STAFF REPORT: 10/08/2025 REGULAR MEETING

APPLICATION NUMBER: HDC2025-00531

ADDRESS: 2224 W. BOSTON

SCOPE: WIDEN DRIVEWAY AND SERVICE PATH, REPLACE CONCRETE PORCH FLOORING AND WALKWAY

2315 / 2325 W. BOSTON

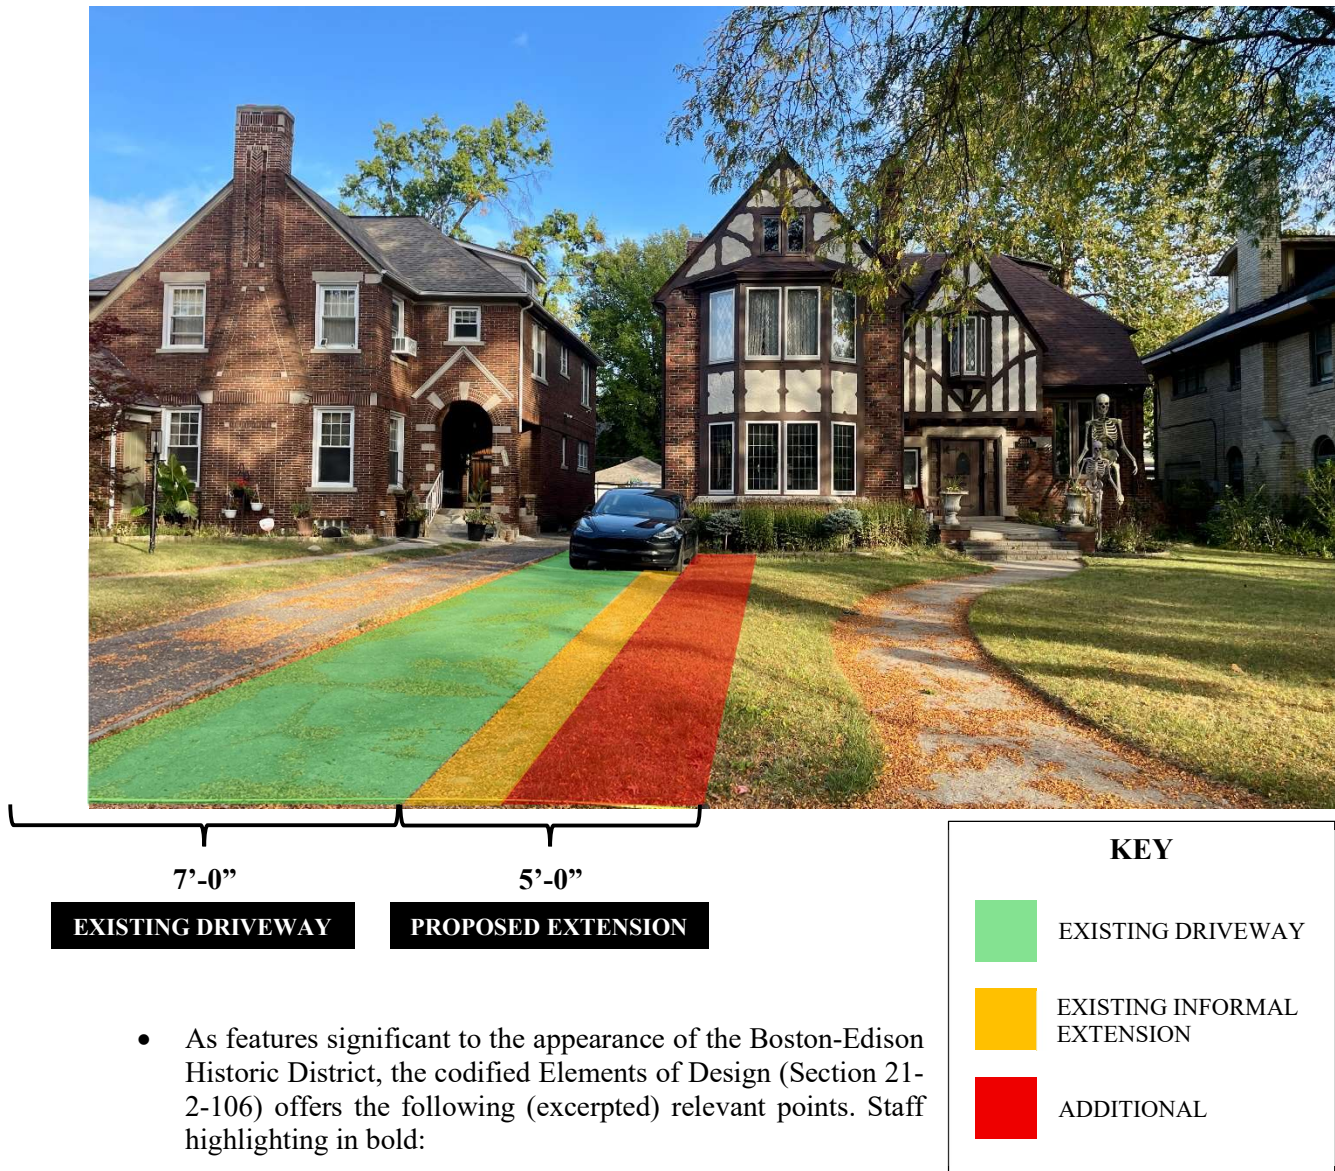
- Sometime between 1974, at designation, and 1980, the curved, brick walkway was replaced with concrete. Staff was unable to locate approval documentation for this alteration.
- Staff field observations for the Boston-Edison Historic District's 'shared' driveways are as follows:
 - The placement/design of the driveways do not extend beyond the side wall of the house and into the front yard.
